Wait Avenue Mixed-Use

Traffic Impact Analysis Review Report

TIA Project: SC-2025-182
Division: 5
County: Wake

Scenario 1

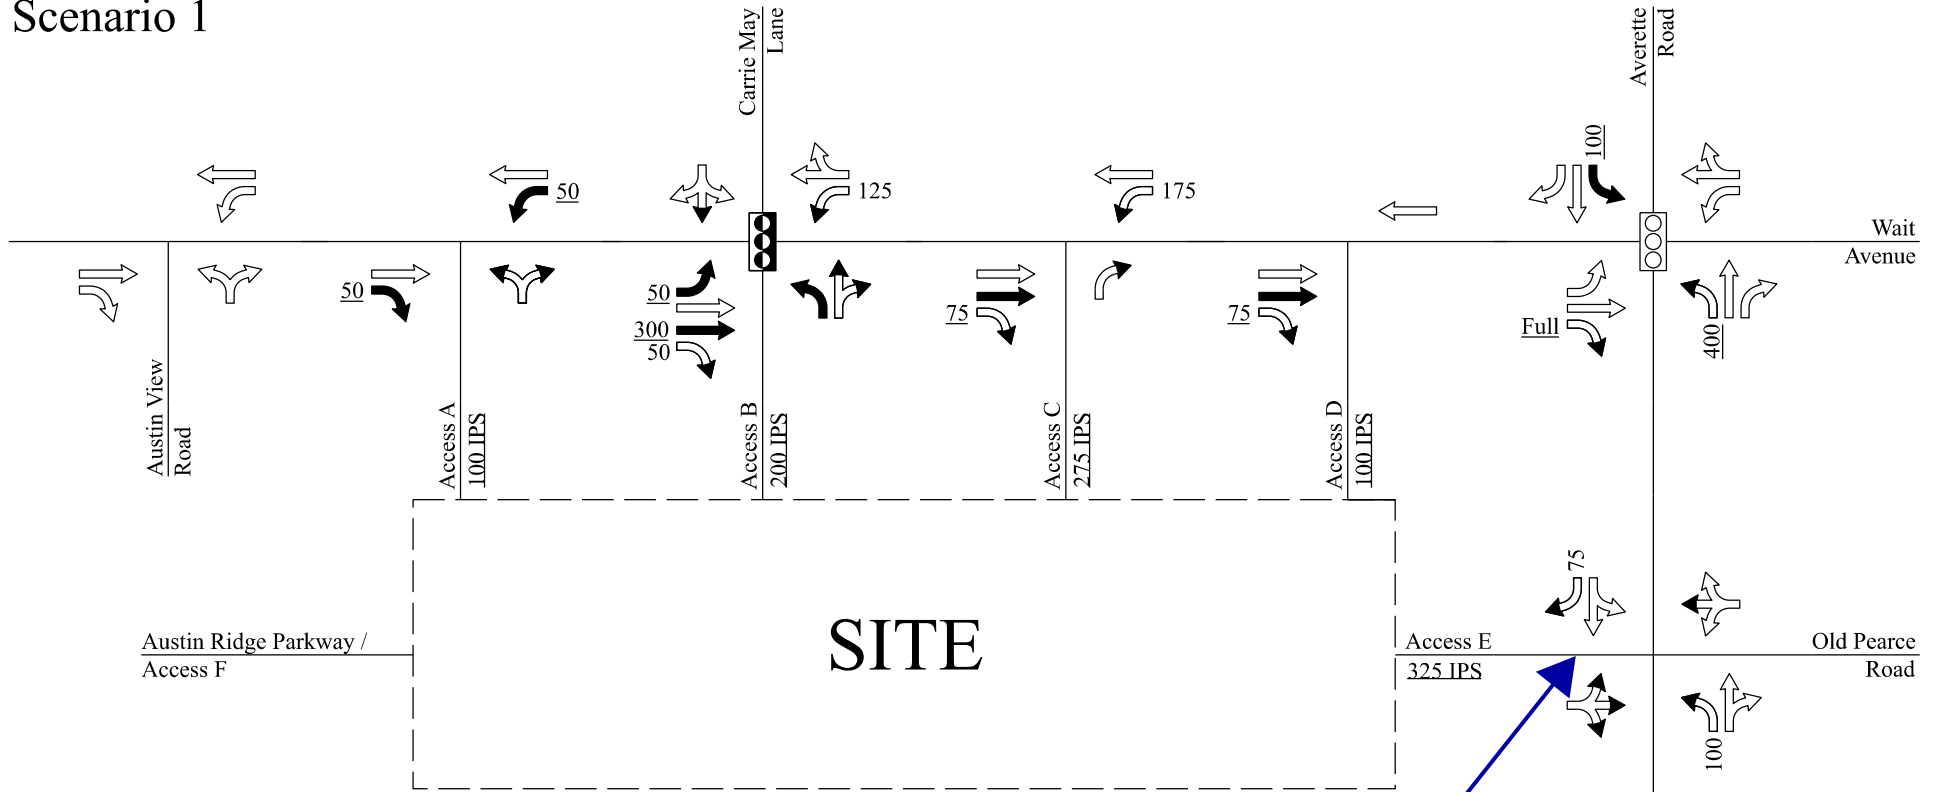
District Note:
Add SB LTL on Averette onto Old Pearce utilizing the pavement provided for the NB LTL - tdd

Scenario 2

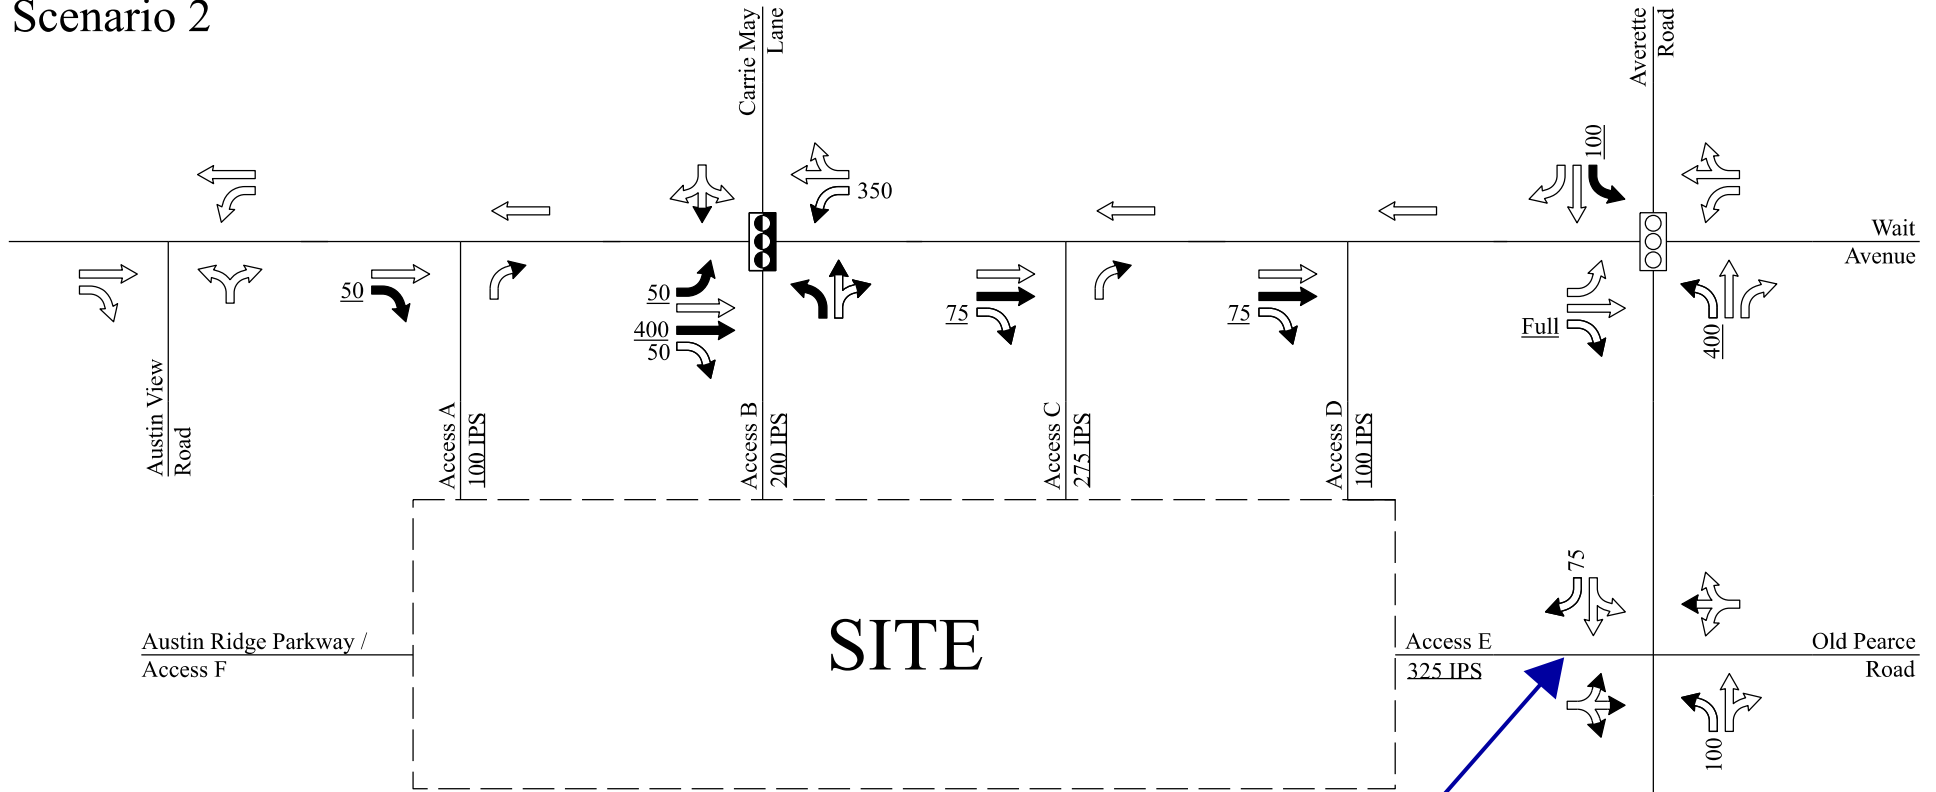
District Note:
Add SB LTL on Averette onto Old Pearce utilizing
the pavement provided for the NB LTL - tdd
